## **Mallard Pass Solar Farm**

**Preliminary Environmental Information Report**

**Appendix 2.1: EIA Scoping Report**

**Scoping Report**

**DWG. NO. Figure 2.5**

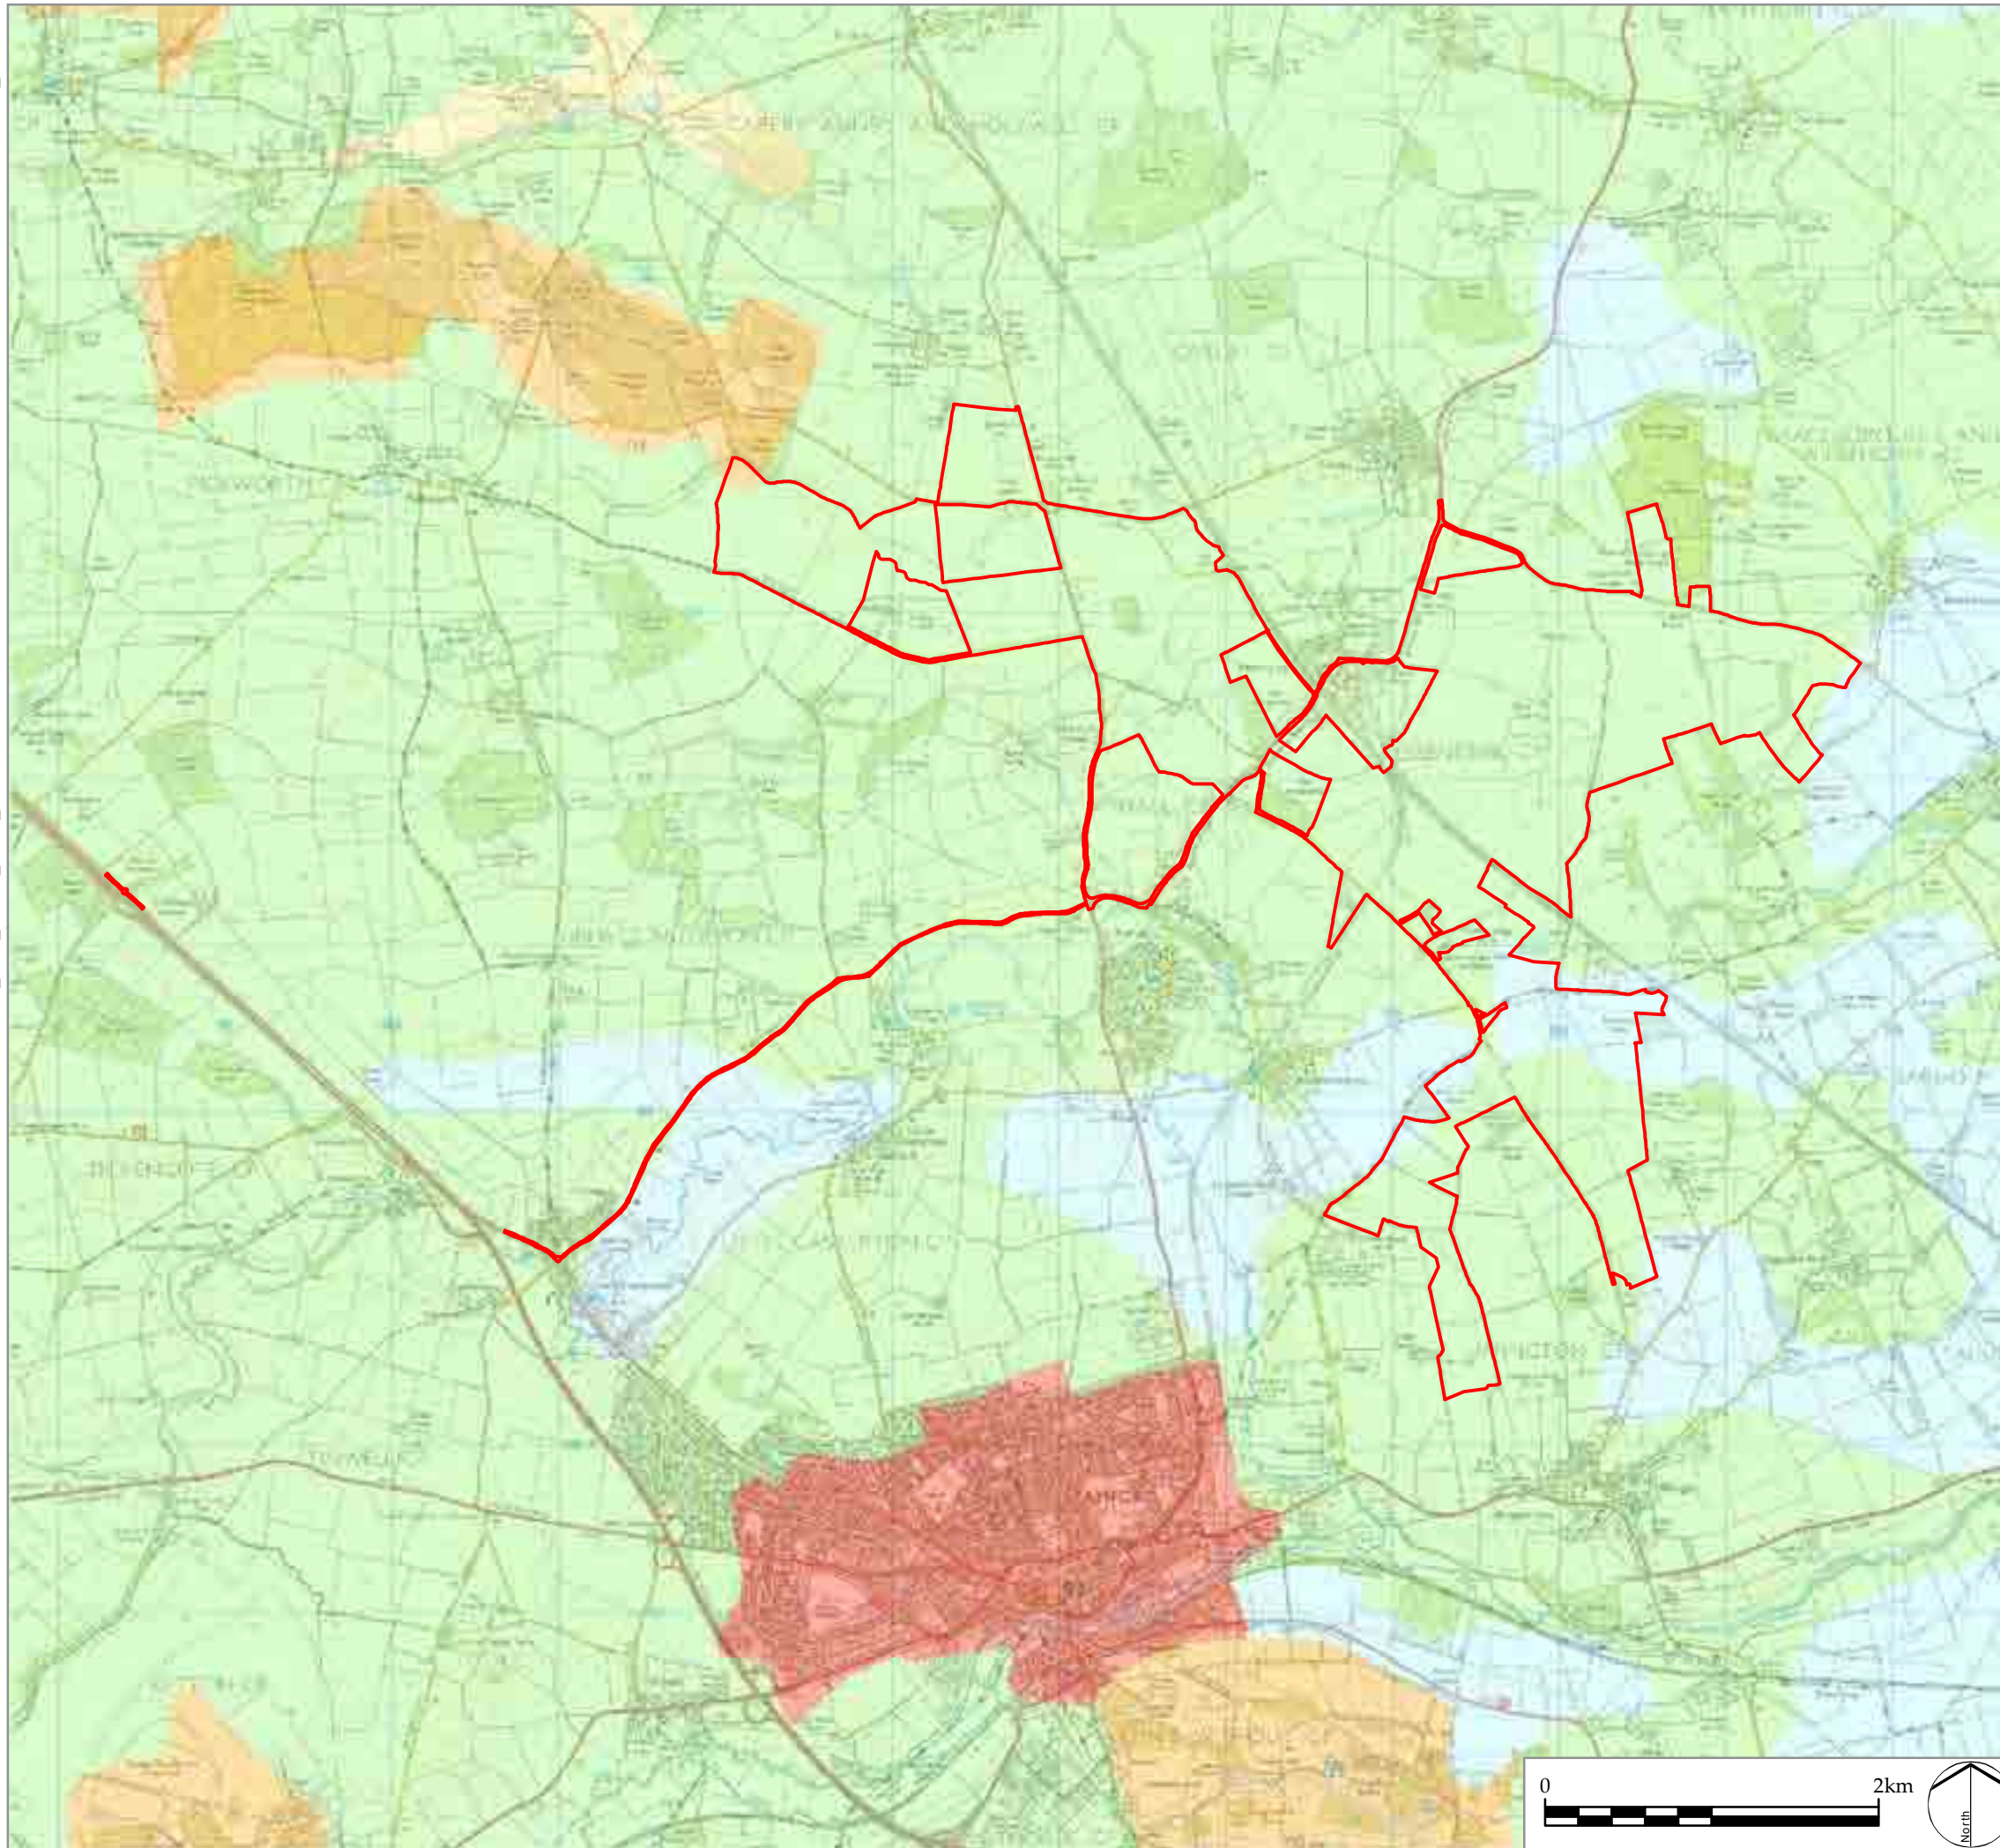
- Figure 2.1 P26. The chart is misleading as the red/orange denote the solar PV site, when in fact those areas also include all the mitigation areas.
- Figure 2.6 P30. Water Resources and Flood extents. This chart does not show the impact on Greatford outside the site, and it only highlights 1 in 20 as the worst case scenario. As above in 2.4.2 we know there is ongoing flooding in Greatford and at the bottom of Essendine hill on a regular basis and the flood risk is likely to increase owing to climate change.

**DWG. NO. Figure 3.1**

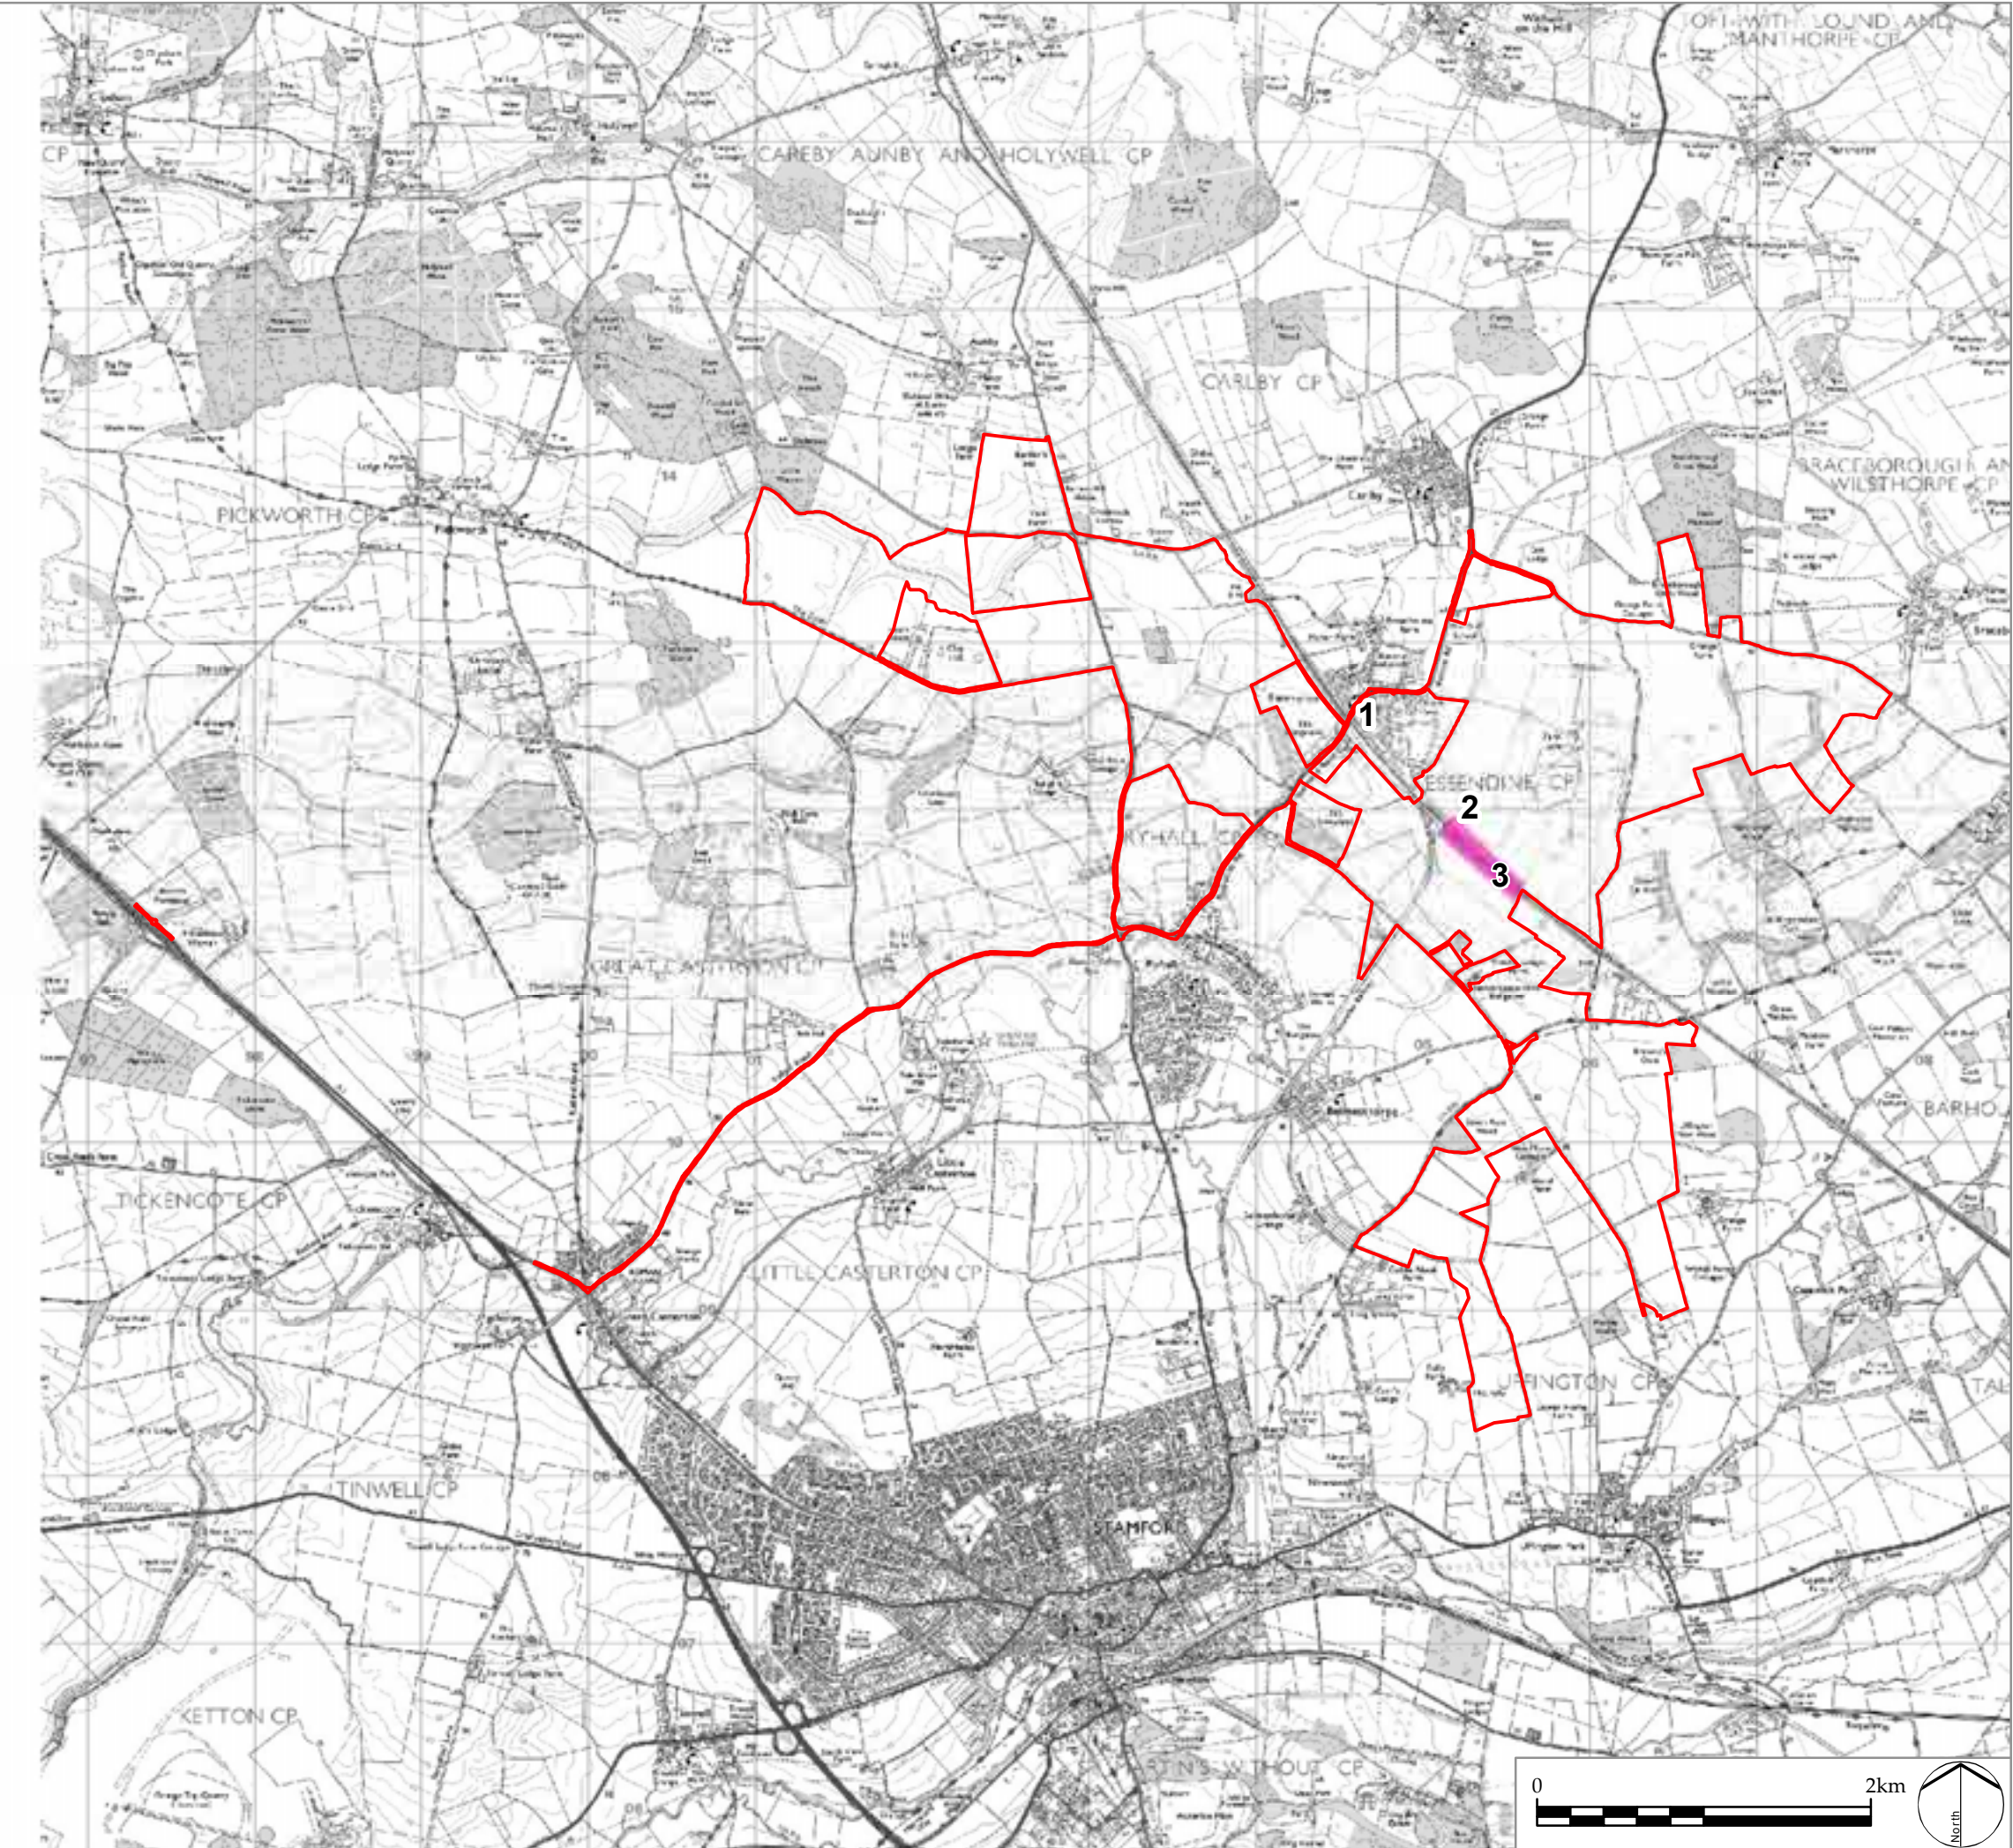
3.2.4 P45 “Potential areas for mitigation and enhancement as identified on Figure 3.1 will also provide areas for green infrastructure and potentially be used to deliver a 10% net gain in biodiversity”.

In the Illustrative Layout Fig 3.1 page 55 of the Scoping Report and subsequent amended versions and ultimately in the Landscape and Ecological Management Plan (LEMP) we would look for buffers and 'Potential Mitigation and Enhancement Areas' to be configured in connection with (roughly in priority order):
